Planning Commission

Revised Meeting Agenda

May 11, 2026 | 6:30 PM

SUBJECT: Building Elevation Modifications, Braelinn Village Shopping Center, Crosstown Drive

BUILDING ELEVATION REVIEW
BRAELINN VILLAGE SHOPPING CENTER
PEACHTREE CITY, GA

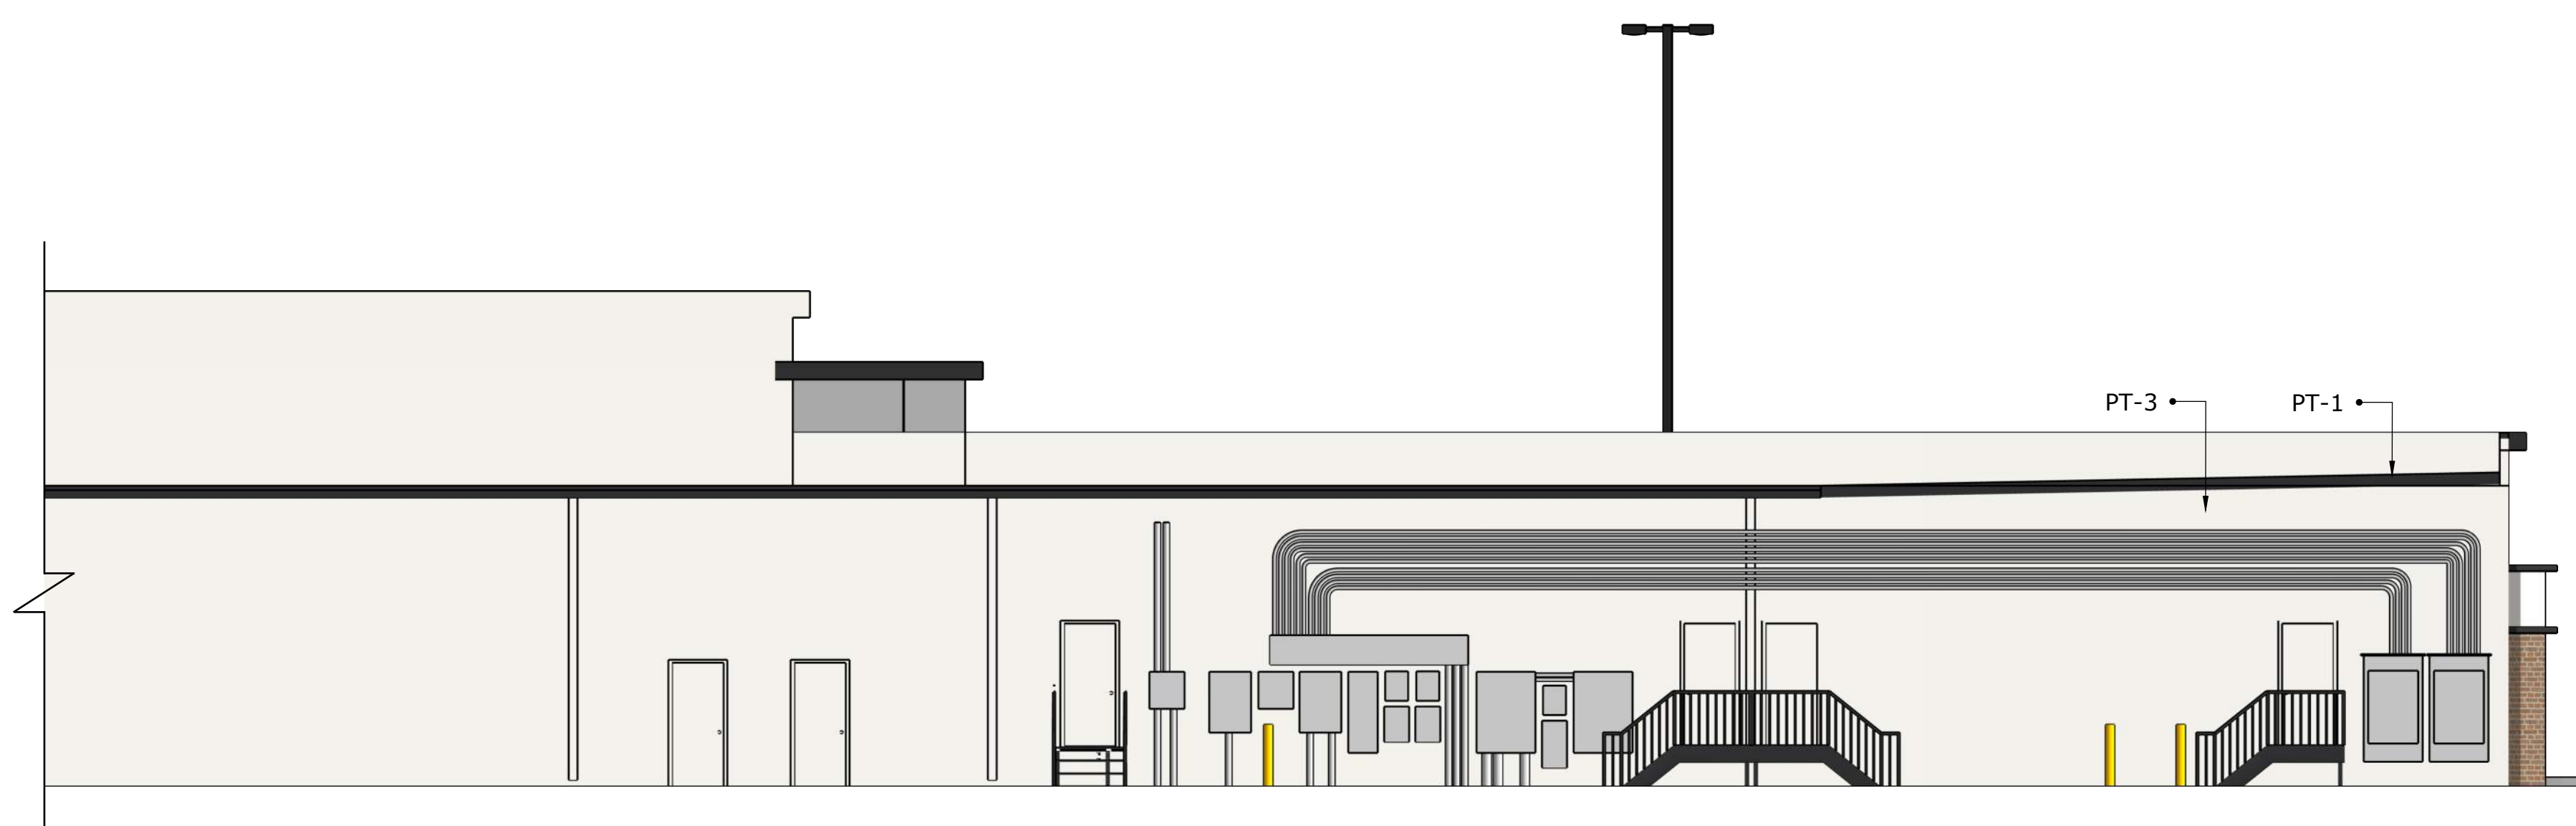
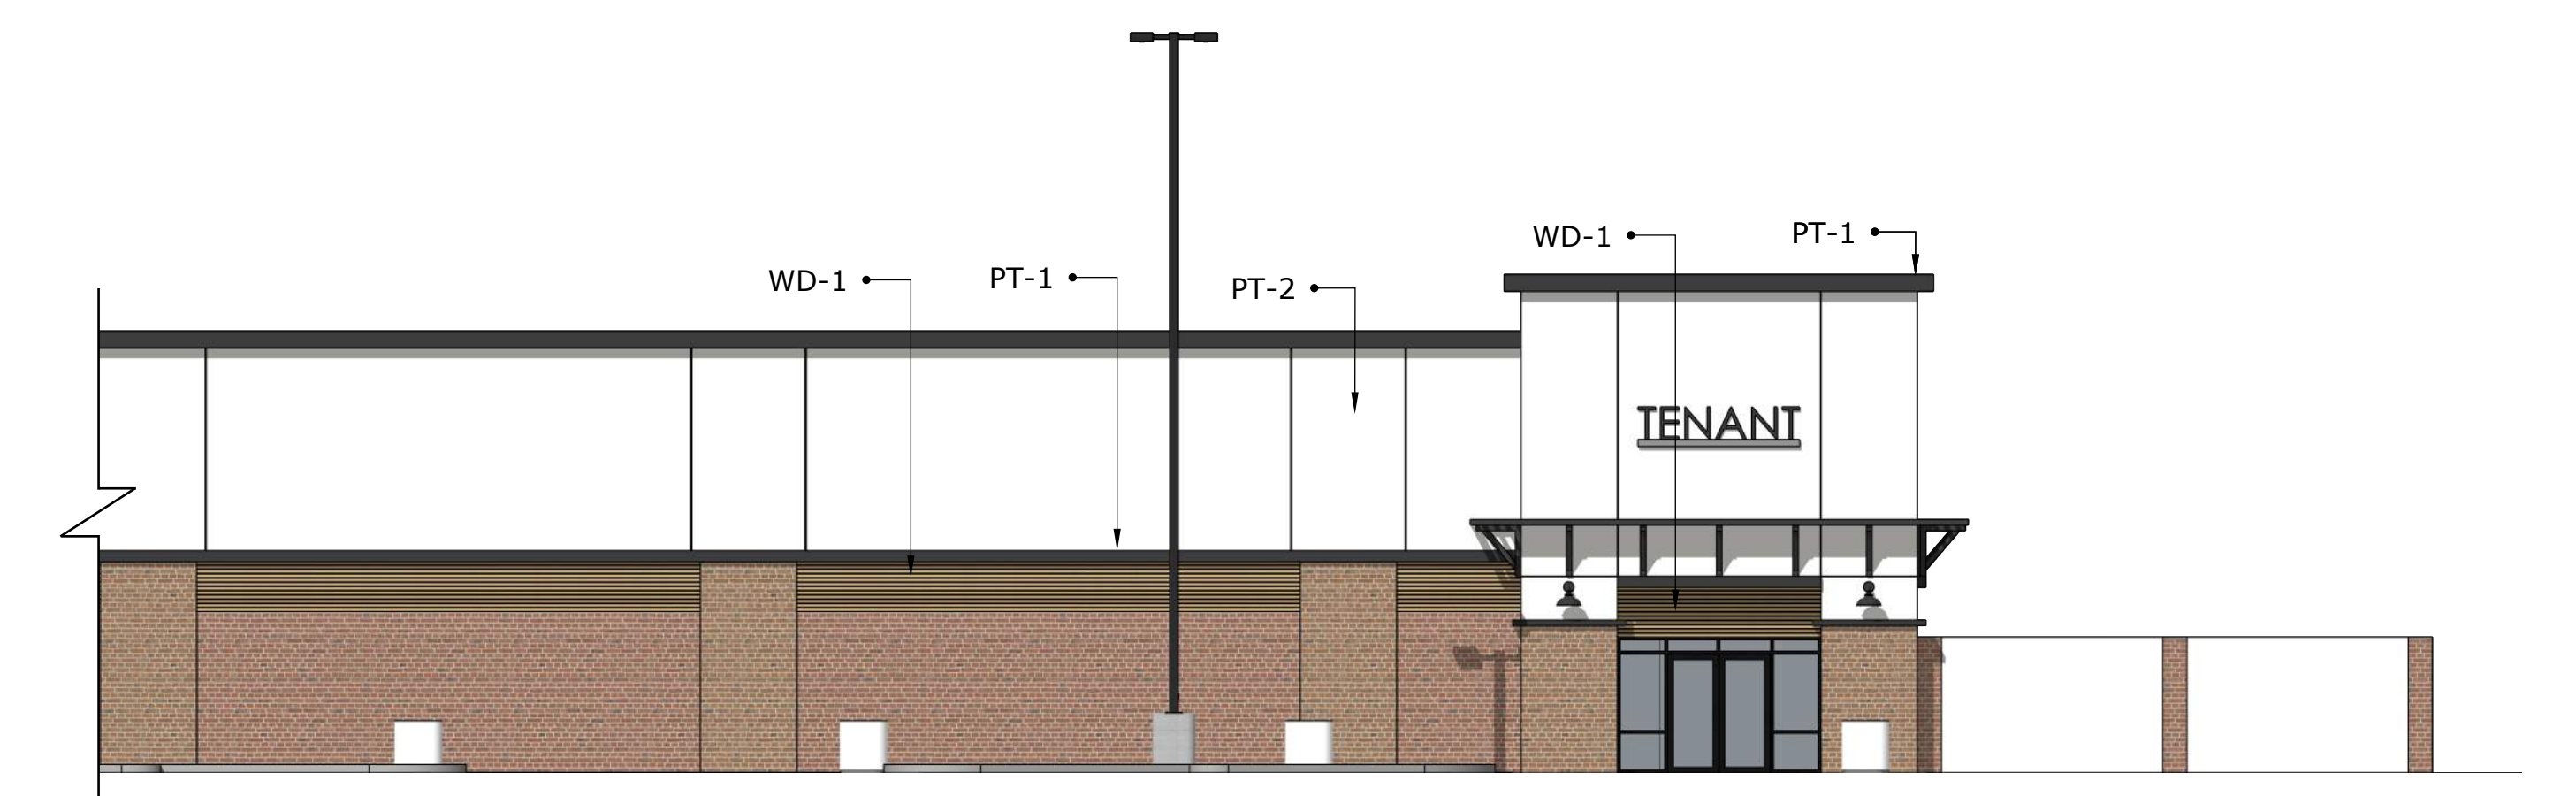
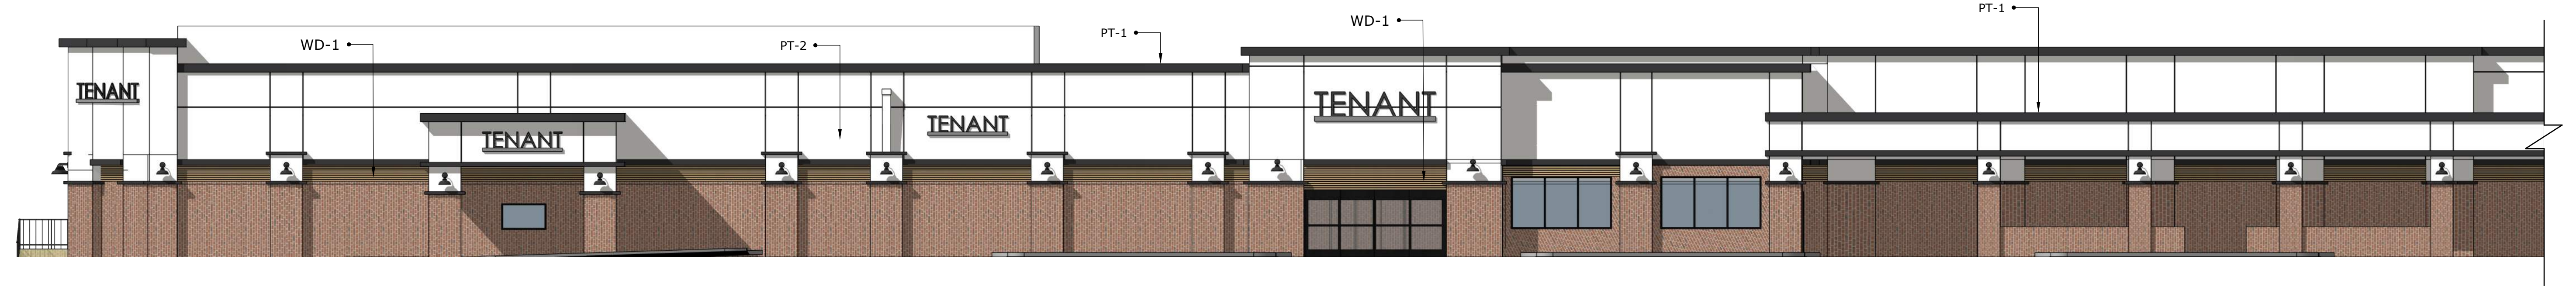
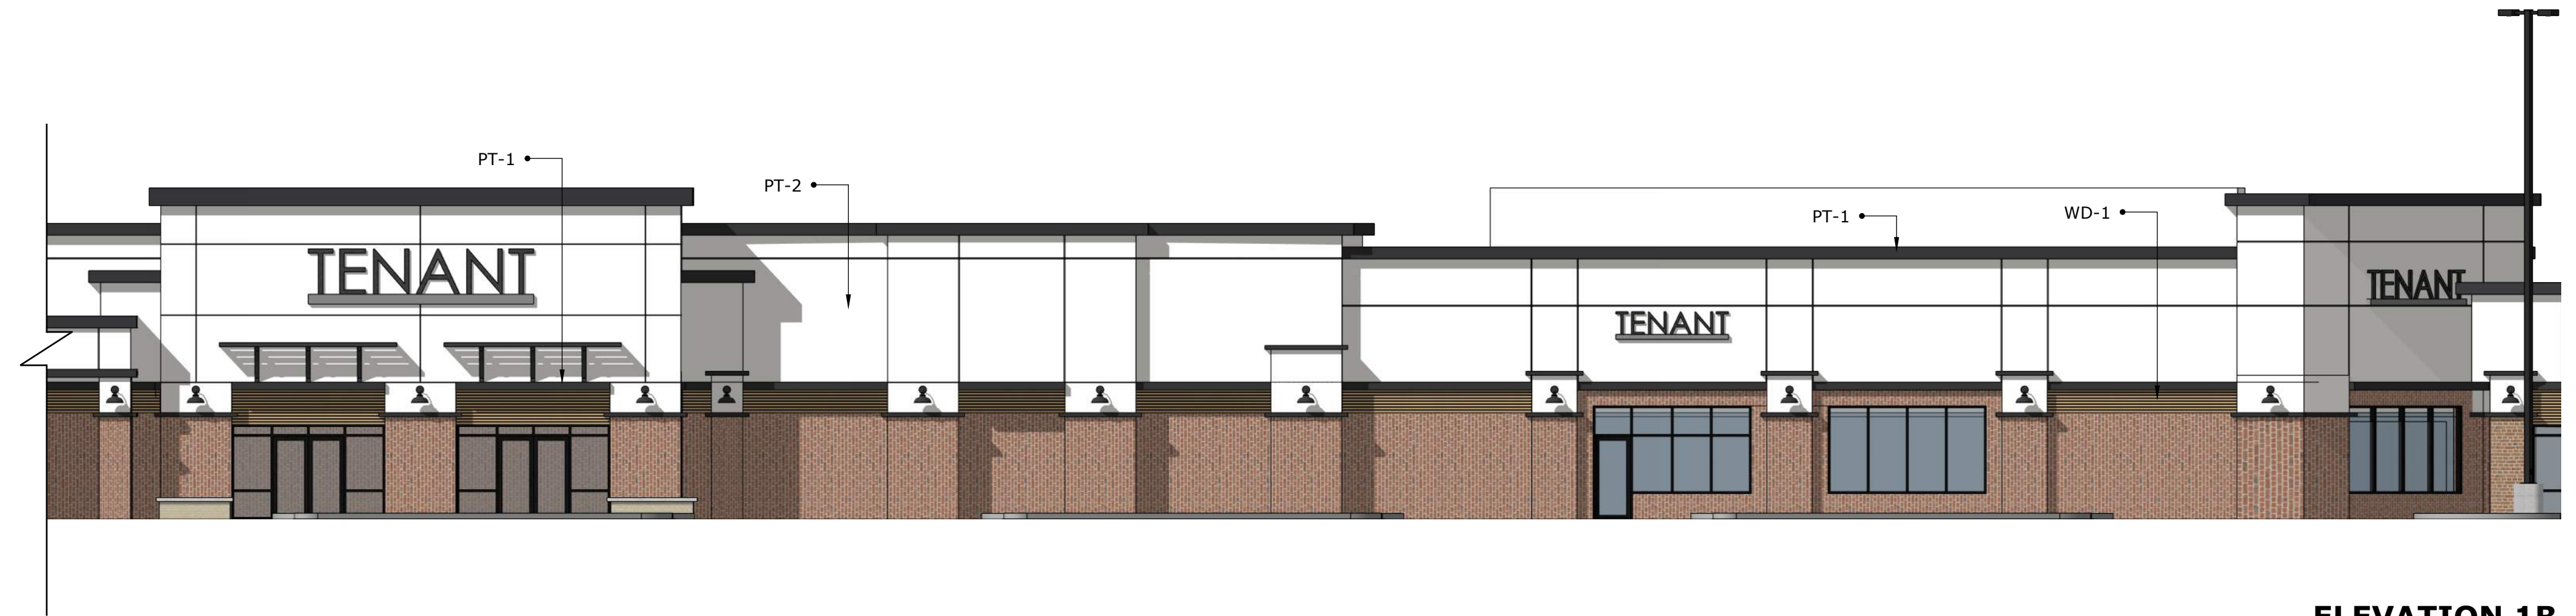
The proposed architectural upgrades for the Braelinn Village Shopping Center located at 564 Crosstown Drive meet the ordinance requirements for architectural innovation and the colors are neutral, blending with the natural environment and surrounding development.

Section 725 of the Land Development Ordinance (LDO) establishes general goals for architectural design, including high quality design and architectural innovation, as well as compatibility with surrounding development and the natural environment. The proposal includes painting the existing EIFS with neutral colors, updating the cornice details, and introducing a faux wood accent made of metal to create a more modern

There is no proposed change to the amount of primary materials (brick or stone) being provided.

1 EXTERIOR ELEVATION - EAST AT 74
1" = 20'-0"

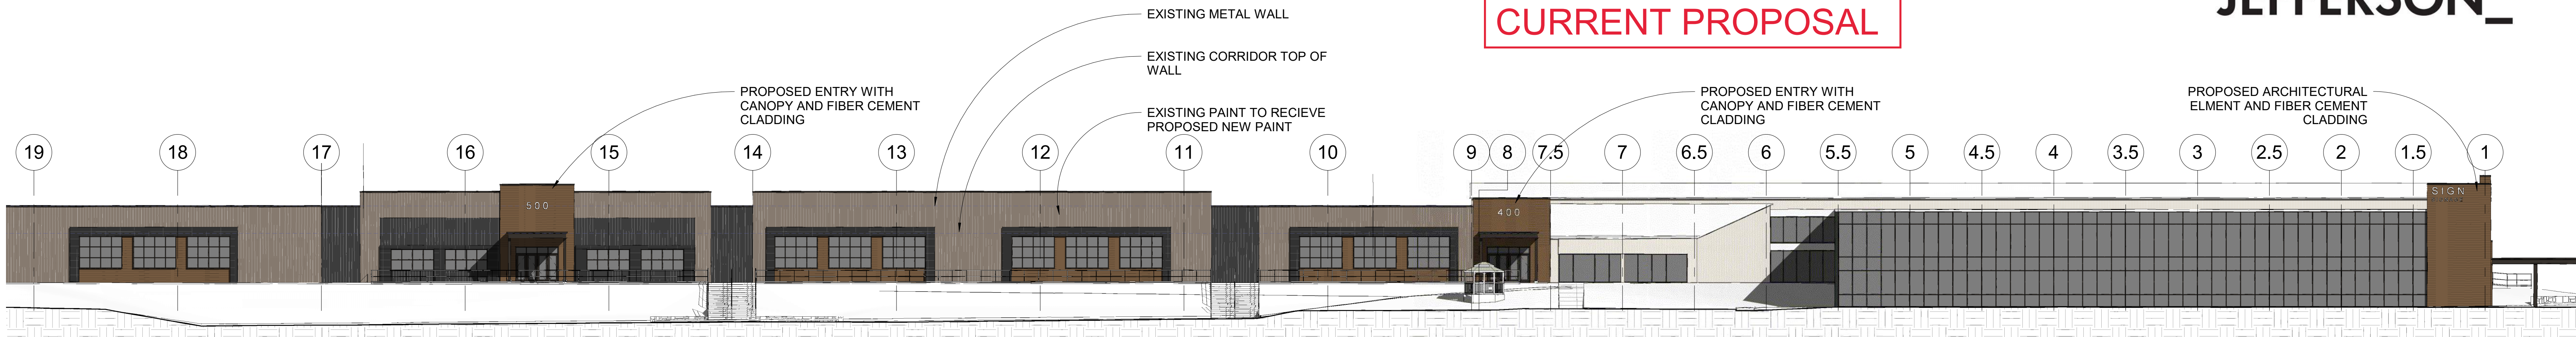
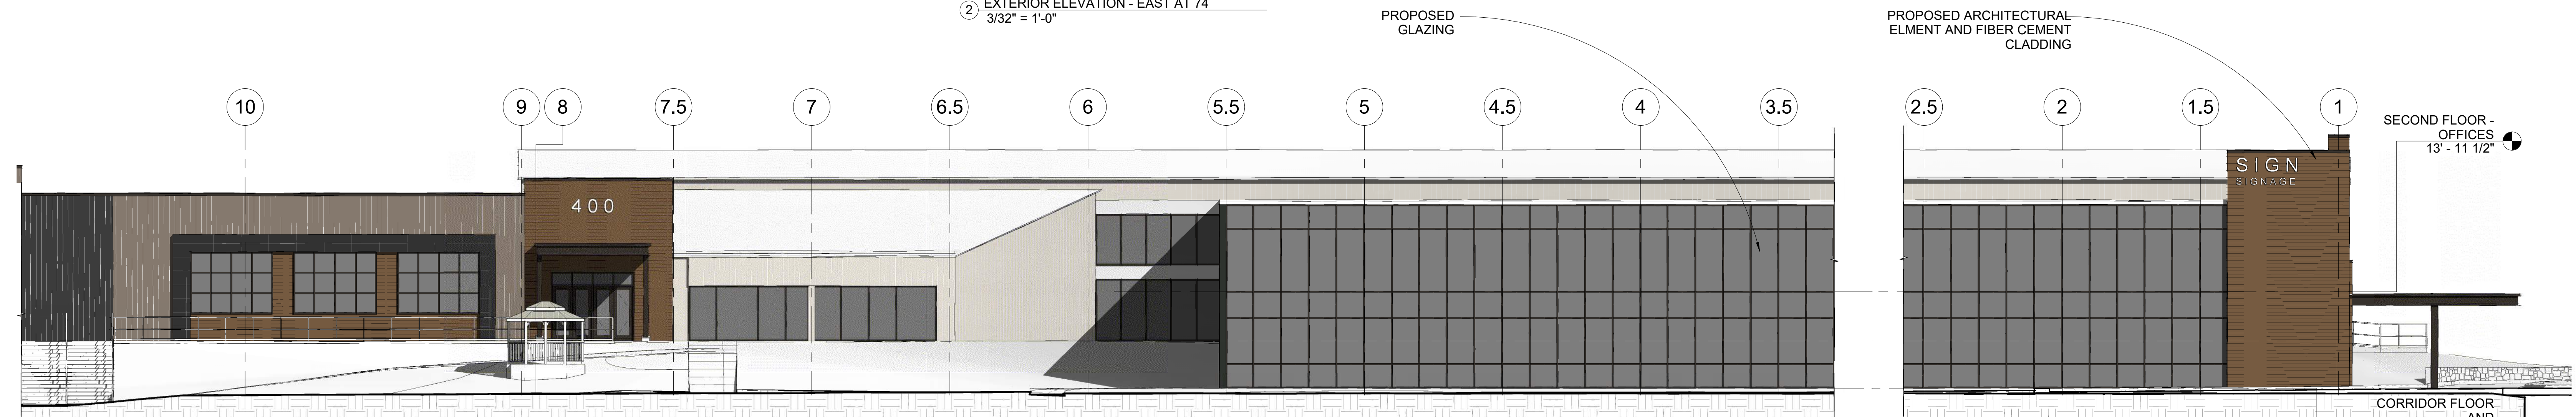
The proposed architectural upgrades for the former NCR building located at 200-259 HWY 74 S meet the ordinance requirements for architectural innovation and the colors are neutral, blending with the natural environment. While this is not a complete renovation of the existing building, the proposal does introduce some primary materials as part of the proposed upgrades. However, the amount is significantly less than 80% for the front and 50% for the side facades as required by the ordinance.

Section 725 of the Land Development Ordinance (LDO) establishes general goals for architectural design, including high quality design and architectural innovation, as well as compatibility with surrounding development and the natural environment. Included in the proposal is fiber cement cladding resembling vintage wood and steel, new storefront windows, and the painting of existing metal panels.

The existing building does not contain any primary materials, such as brick or stone. The proposed upgrades introduce fiber cement siding, which is a long-lasting, low-maintenance material similar to brick and stone.

The east facade facing HWY 74 (front of the building) will contain 3,263 SF of new fiber cement siding, which is approximately 31% of the facade (not counting glass in the calculation). The north facade (facing Paschall Rd.), which was previously approved, will contain 3,200 SF of new fiber cement siding, approximately 36% of the facade (not counting glass in the calculation).
